| Title | Corrections for the 3 Way SA-TEK Exchange | |
| Re: | IEEE P802.16e/D7 | |
| Purpose | Adoption of proposed changes into P802.16e/D7 | |

Corrections for the 3 Way SA-TEK Exchange

0.1 IEEE P802.16e/D7 Status

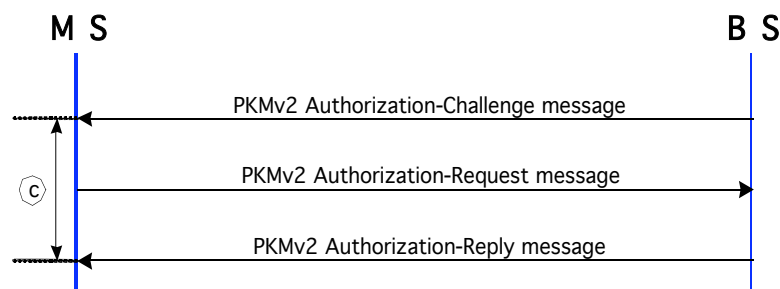
There are messages related to 3 way handshake SA-TEK exchange, e.g. SA-Challenge, SA-TEK-Request, and SA-TEK-Response. These messages are used during initial network entry, reauthorization, HO.

- The Security_Capabilities, SAID, and SA-Descriptors attributes are included in SA-TEK exchange. However, negotiation of Security_Capabilities and SA-Descriptor should be done before the MS generates and distributes the TEK. It is reasonable that those attributes should be negotiated during the AK generation procedure.

- The SA-Descriptors included in SA-TEK exchange identifies the Primary and Static SAs the requesting MS is authorized to access and their particular properties. In the case of the multicast service, it is so dangerous to distribute the information of all Static SAs (including static SAID and static TEK-parameters) without DSx-exchange procedure (= without user's use intention for the multicast service). In order to use this SA-TEK exchange procedure, all DSx-exchanges for Static SAs should be performed.

- It is already defined that the TEK doesn't need to be updated during reauthorization in the IEEE P802.16d/D5. Thus, the TEK doesn't need to be refreshed during HO. The TEK-parameters transfer and share among BSs should be guaranteed. If not, no information shall be shared among BSs and even HO-optimization is impossible.

- a) It is appropriate that Security_Capabilities and SA-Descriptors should be transferred not during the TEK exchange procedure but during the MS's AK generation procedure. The following MS's Authorization Key Generation procedure shall support the above solution and transfer those attributes securely.

- i. PKMv2 Authorization-Challenge message: BS_Nonce
 - ii. PKMv2 Authorization-Request message: Key Sequence Number (PAK), MS_Nonce, BS_Nonce, Security_Capabilities, SAID, OMAC Digest (from AK)
 - iii. PKMv2 Authorization-Reply message: Key Sequence Number (AK), Key Lifetime (AK), BS_Nonce, (one or more) SA-Descriptor(s), OMAC Digest (from AK)
 - iv. PKMv2 Authorization-Reject message: Error-Code, Display-String, BS_Nonce, OMAC Digest (from AK)
- b) The DSx-exchange procedure (user's intention) should precede the TEK exchange procedure, especially the multicast service to use Static SA. It is appropriate to use the PKMv2 Key-Request and the PKMv2 Key-Reply message after performing DSx-exchange procedure.
